Access Compliance Report

Public Rights-of-Way

(Curb Ramps)

Intersection ID: 26209	Main Street: CARMEL_RD	Cross Street: JOHNSTON_RD	Location: S
ADA ID: C2D9DB965A27	Ramp Type: Perp	Initial Pass/Fail: Fail	Overall Compliance: No
Severity Score: 21.25			
Codes/Mitigation Info/Possible Solution		Field Measurements/Component Compliance

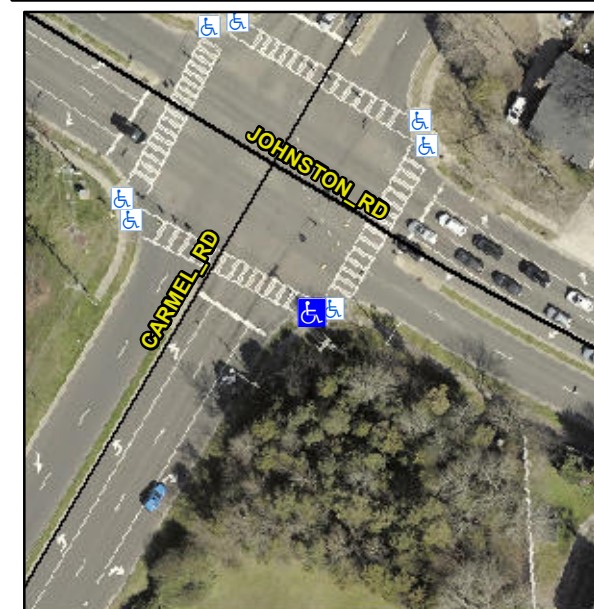
Not Found, R304.5.1, R304.5.3

Compliance	Description	Data	Compliance	Description	Data
N/A	Ramp Length (in)	60.0	Yes	Ramp Slope (%)	7.5
No	Ramp Width (in)	46.5	No	Ramp XSlope (%)	6.0
N/A	Flare Type LT	N/A	N/A	Flare Type RT	N/A
N/A	Flare Slope LT (%)	N/A	N/A	Flare Slope RT (%)	N/A
N/A	Flare Traversable LT?	N/A	N/A	Flare Traversable RT?	N/A
N/A	Landing Length (in)	N/A	N/A	DWS Provided?	N/A
N/A	Landing Width (in)	N/A	N/A	DWS Contrast?	N/A
N/A	Landing Slope (%)	N/A	N/A	DWS Length (in)	N/A
N/A	Landing X Slope (%)	N/A	N/A	DWS Full Width?	N/A
N/A	Landing Curb? (Y/N)	N/A	N/A	DWS Offset (in)	N/A
N/A	Shared Landing?	N/A			
N/A	Gutter Ponding?	N/A	N/A	Gutter Slope (%)	N/A
N/A	Gutter Lip Ht (in)	N/A	N/A	Gutter X Slope (%)	N/A
N/A	Painted X Walk1?	Yes	N/A	Painted X Walk2?	N/A
	X Walk 1 Direction	To NW		X Walk 2 Direction	N/A
N/A	X Walk 1 Width (in)	112.0	N/A	X Walk 2 Width (in)	N/A
	X Walk 1 Slope (%)	3.5		X Walk 2 Slope (%)	N/A
	X Walk 1 X Slope (%)	4.1		X Walk 2 X Slope (%)	N/A

Remove & Replace Entire Ramp.
